IEEE P802.15
Wireless Personal Area Networks

Project	IEEE P802.15 Working Group for Wireless Personal Area Networks (WPANs)	
Title	TG3 LB19 comment resolution	
Date Submitted	[31 October, 2002]	
Source	[James P. K. Gilb] [Apparent Technologies] [9921 Carmel Mountain Rd. #247, San Diego, CA 92129]	Voice: [858-538-3903] Fax: [858-538-3903] E-mail: [gilb@ieee.org]
Re:	[]	
Abstract	[This document is a record of comment resolutions for LB19.]	
Purpose	[To provide a record of the comment resolution for LB19.]	
Notice	This document has been prepared to assist the IEEE P802.15. It is offered as a basis for discussion and is not binding on the contributing individual(s) or organization(s). The material in this document is subject to change in form and content after further study. The contributor(s) reserve(s) the right to add, amend or withdraw material contained herein.	
Release	The contributor acknowledges and accepts that this contribution becomes the property of IEEE and may be made publicly available by P802.15.

1. Conference calls, San Diego to Kauai

Figure 19—PNC handover MSC

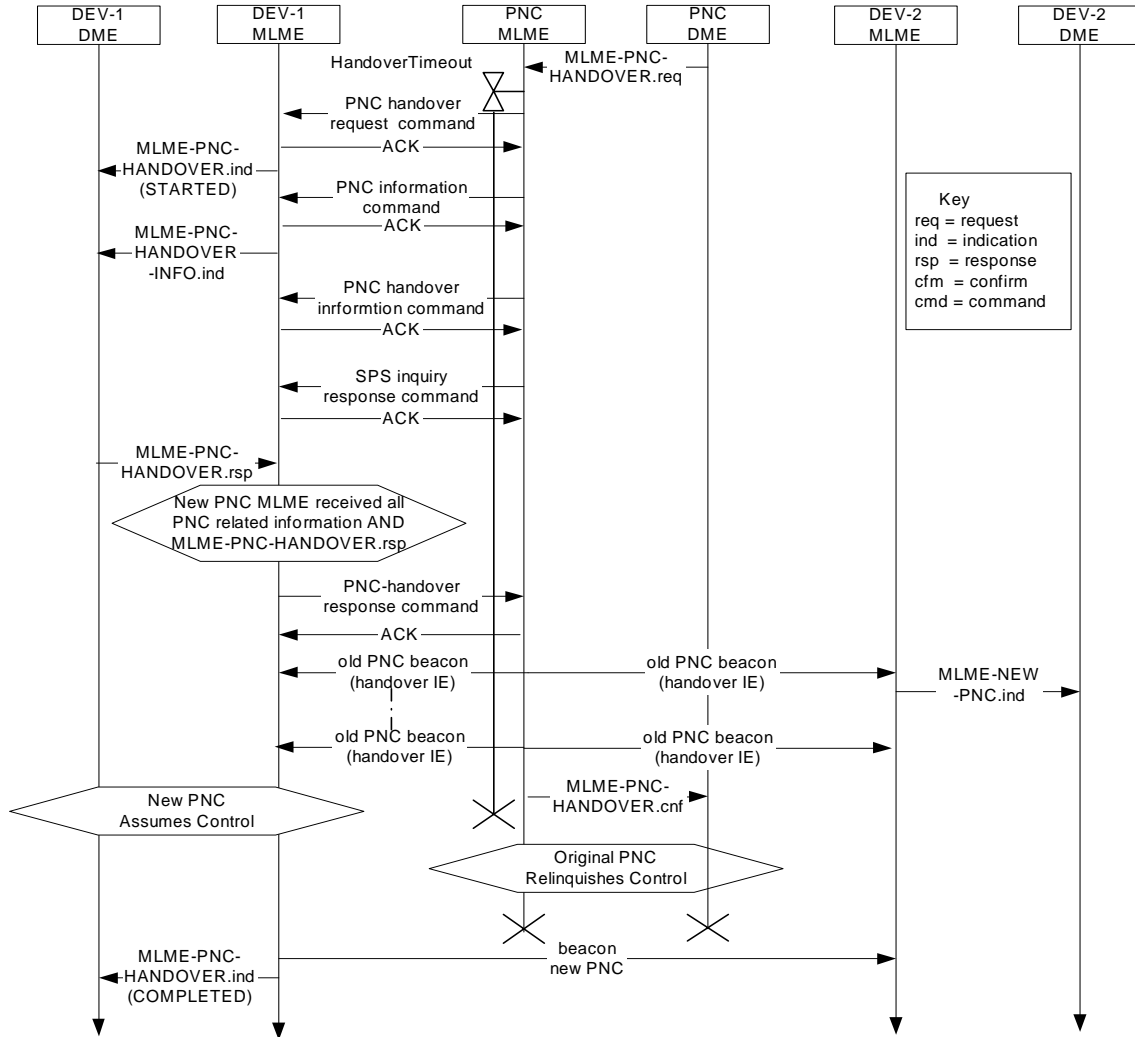
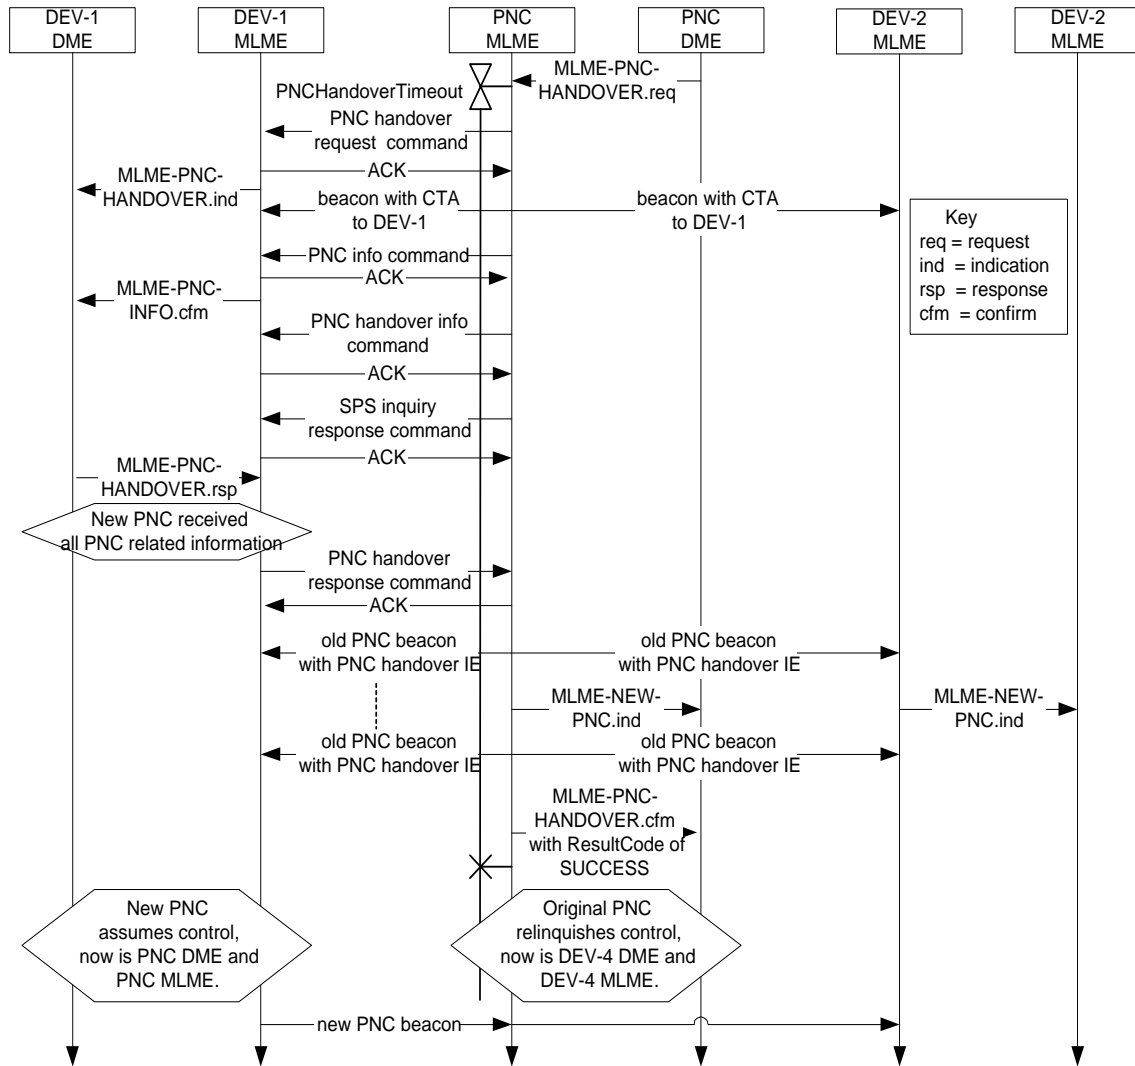
269 (Heberling, TR) - [PNCHndOvr] Some errors in text remain or were introduced after LB17.MSC in Figure 91 is also wrong./KO Text changes for 8.2.3 and ne MSC for Figure 91 are all collected in:02276r7P802-15_TG3-commentsD11_KO.doc, Resolution [03]. **Suggest accept in principle**, “The MSC will be modified as indicated in the resolutions of CID 58 and 232. Make the following text changes: In 6.3.13.4, page 59, line 45, change ‘This primitive informs the originating DME its request for information from the PNC is complete.’ to be ‘This primitive informs the DME that the MLME has received a PNC information command, {xref 7.5.4.2}.’ In 7.5.3.1, page 138, line 20 ‘the number of information records to be transferred using the PNC information command frame(s).’ to be ‘the number of DEV information records, {xref PNC handover info command}, that will be transferred from the old PNC to the new PNC.’ In 8.2.3 PNC Handover, delete page 156, line 8-9, redundant, same text in paragraph below. Add to page 156, line 19, ‘The PNC handover information command shall not be sent if the PNC has indicated in the PNC handover request command that it does not have any CTRBs to transfer.

463 (Gubbi, TR) - Figure-91 is a well done job, but the text needs to supplement some info that can not be expressed in the figure, which is incomplete in the current update to this para. It should be mentioned that these commands shall be sent by PNC even if there is no information present that fits into those commands so that the rx-DEV knows the exact end of the transaction. For example, what if there are no DEVs in power save mode. Still the SPS-inquiry-response-command shall be sent by PNC. It should be mentioned that the three commands in Figure-91 (PNC-info-command, PNC-handover-info-command and SPS-inquiry-response-cmd) shall be sent by PNC even if there is no information present that fits into those commands so that the rx-DEV knows the exact end of the transaction. For example, what if there are no DEVs in power save mode. Still the SPS-inquiry-response-command shall be sent by PNC. **Suggest accept in principle,** "Rather than send the empty commands, the PNC handover request will contain the number of CTRBs and SPS sets that will be transferred. If the number of items is zero, then the old PNC shall not send the command and the new PNC will not expect to receive it. It is not possible for the number of DEVs to be less than 2 (i.e. the old PNC and the new PNC), so the PNC information command will always be sent. This is documented in the resolution of CID 269."

The SPS inquiry response command shall not be sent if the PNC has indicated in the PNC handover request command that it doesn’t have any SPS sets to transfer.’

Add to page 156, line 35, ‘The new PNC shall broadcast its first beacon at the time the beacon would have been sent by the old PNC. This time may vary from the actual time due to clock inaccuracies of old and new PNCs. The new PNC shall start sending beacons with the beacon number counter set to one more than the beacon number of the last beacon that will be sent by the old PNC.’

Add page 156, line 40ff, ‘The PNC shall ensure that the beacon countdown includes at least one system wake beacon and at least aMaxLostBeacons beacons following that system wake beacon. The only exception to this requirement is if the PNC will be shutting down and does not have enough time to to wait for the next system wake beacon to complete the handover process. {Ed. note: This line may be moved to a new 8.1.1 that describes all beacon announcements.’}

Figure 21—Illustration of bit ordering for data payload and text fields.

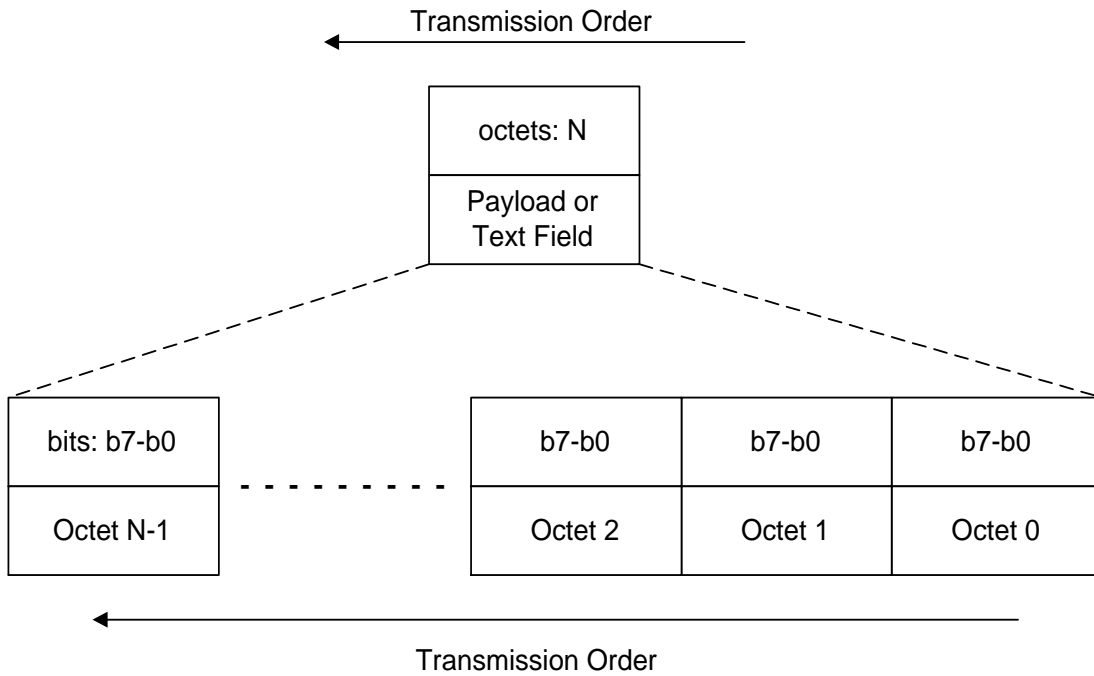
345 - ACCEPT IN PRINCIPLE. Add ‘The payload in the data frame is sent with the lowest numbered octet first, least significant bit first, over the air.’ to the beginning of line 51. After ‘the highest numbered bits.’ add ‘For any text fields, the first character is in the first octet of the field with other characters following sequentially.’ Also add a new figure for the data payload from 02/392r4.

192 - ACCEPT IN PRINCIPLE. Add ‘The payload in the data frame is sent with the lowest numbered octet first, least significant bit first, over the air.’ to the beginning of line 51. After ‘the highest numbered bits.’ add ‘For any text fields, the first character is in the first octet of the field with other characters following sequentially.’ Also add a new figure for the data payload from 02/392r14.
